Staff Report: PHO-2-22--Z-47-17-8

<u>APPLICATION #:</u>	PHO-2-22--Z-47-17-8
<u>LOCATION:</u>	Approximately 130 feet north of the northwest corner of 19th Avenue and Latona Lane
<u>EXISTING ZONING:</u>	R1-10
<u>ACREAGE:</u>	5.12
<u>REQUEST:</u>	1) Modification of Stipulation 1 regarding general conformance with the site plan date stamped July 28, 2017. 2) Review of conceptual elevations by the Planning Hearing Officer per Stipulation 4.
<u>APPLICANT:</u>	Terrascape Consulting, LLC
<u>OWNER:</u>	Bella Rosa Partners, LLC
<u>REPRESENTATIVE:</u>	Terrascape Consulting, LLC

EXHIBIT II

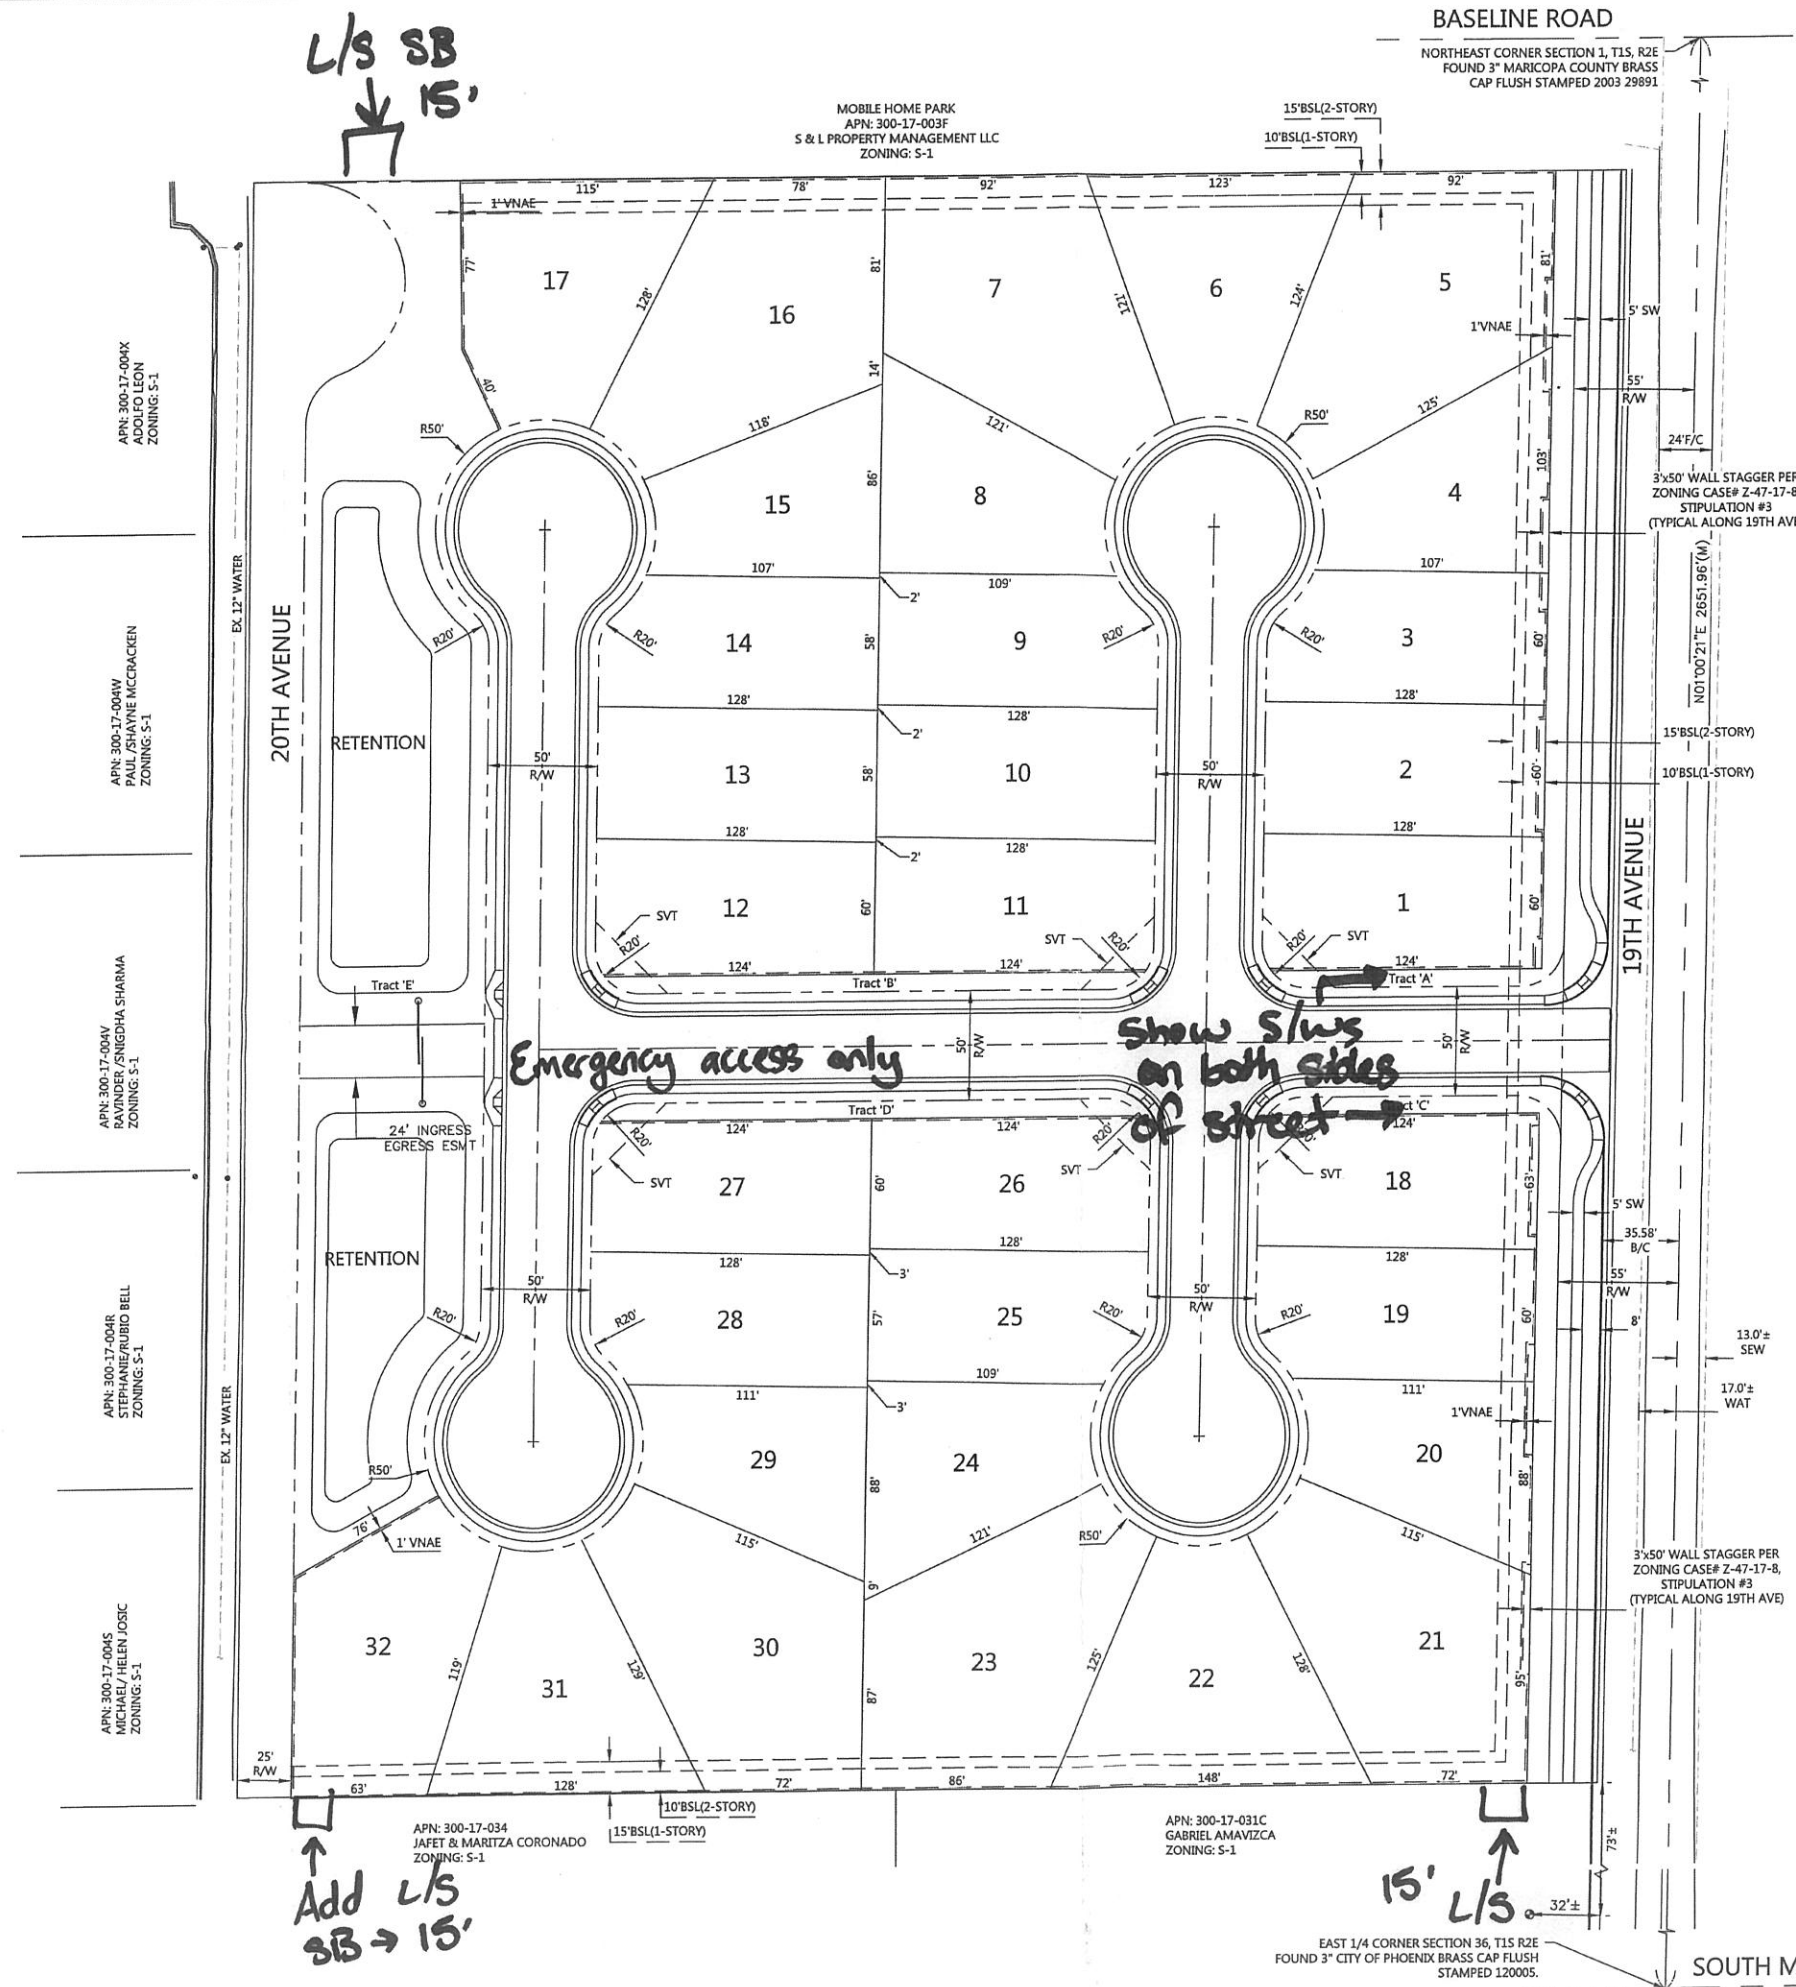
L/S SB
↓
15'

↑
Add L/S
SB → 15'

- Show open space
w/ amenities +
access

- Add tract table
w/ uses
- Add wall plans
w/ details

PRELIMINARY SITE PLAN
 BELLA ROSA
 PHOENIX

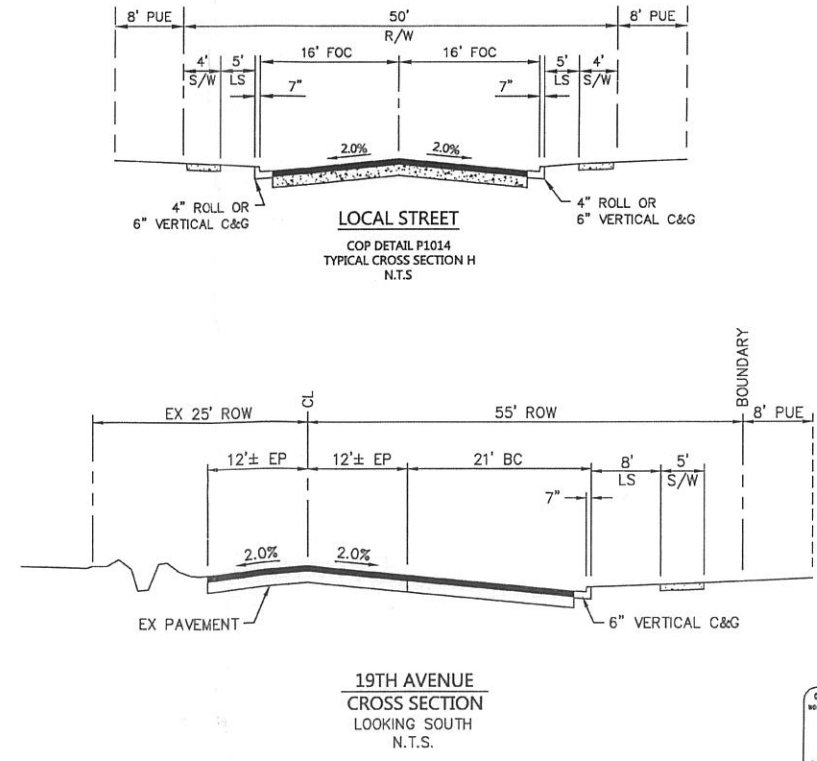
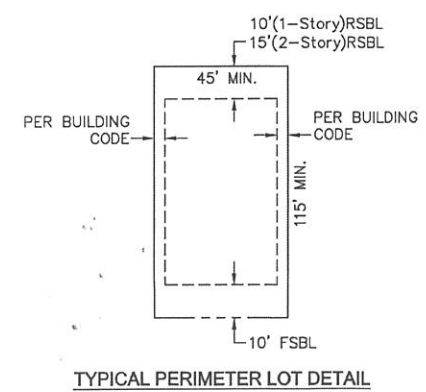
Show density calcs

EXHIBIT I

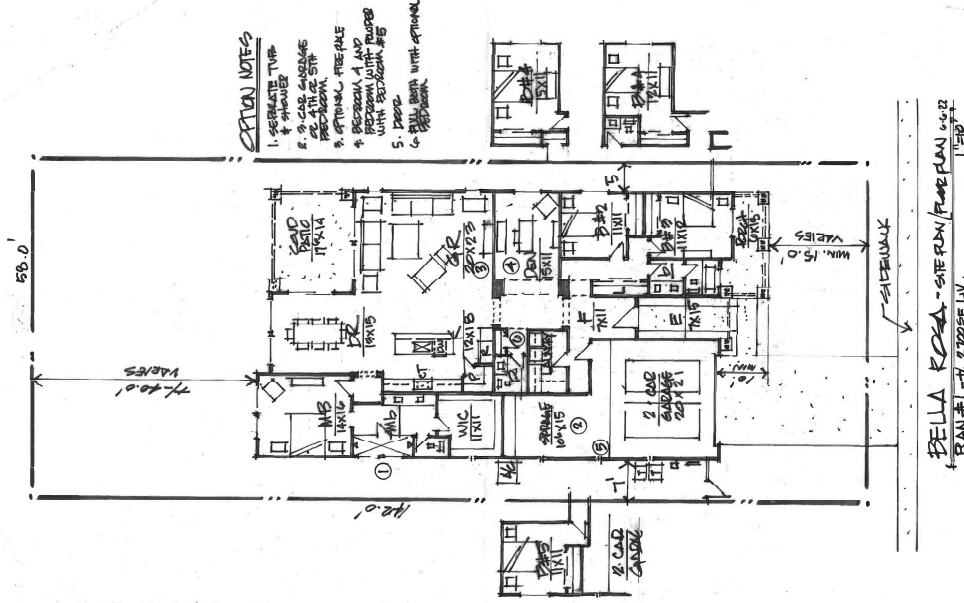
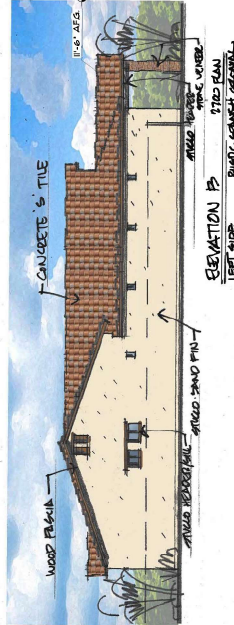
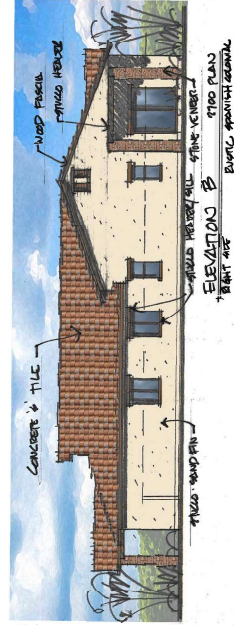
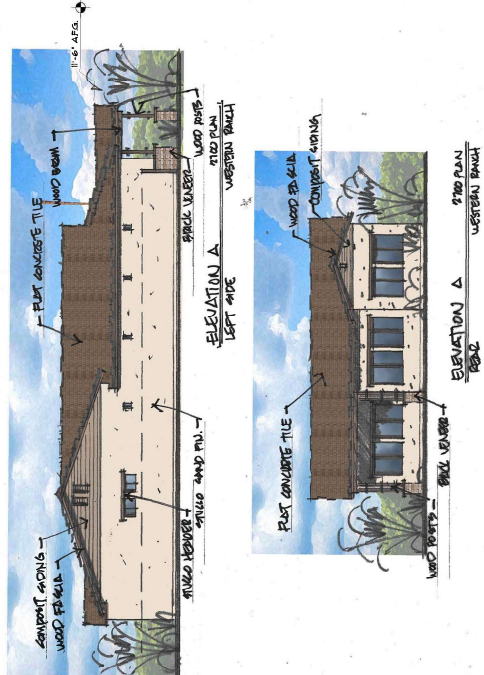
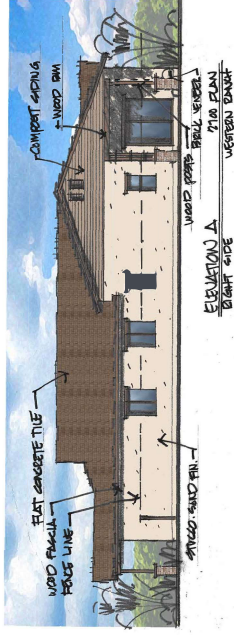
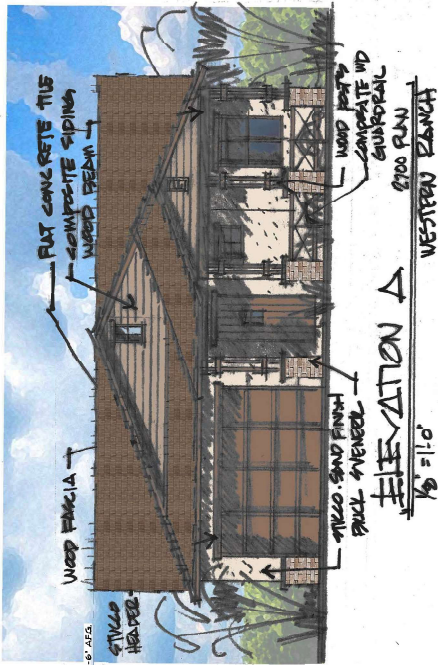
- 3) The applicant submitted conceptual elevations for review and approval per the requirements of Stipulation 4. The stipulation has been complied with and is recommended to be deleted and replaced with a standard language stipulation for general conformance to the elevations provided. Stipulation 4 states that the elevations submitted should be consistent with recommendations in the Rio Montaña Area Plan. The elevations depict a variety of building materials (stone façade, composite siding, wood elements, brick veneer), multiple building colors, variation in roof design, and multiple architectural features (wood posts, gable ornamentation, varied window sizes, decorative garage panels). This diversity is

consistent with the Rio Montaña Area Plan and many of the design choices are compatible with the rural and agricultural character described in the plan.
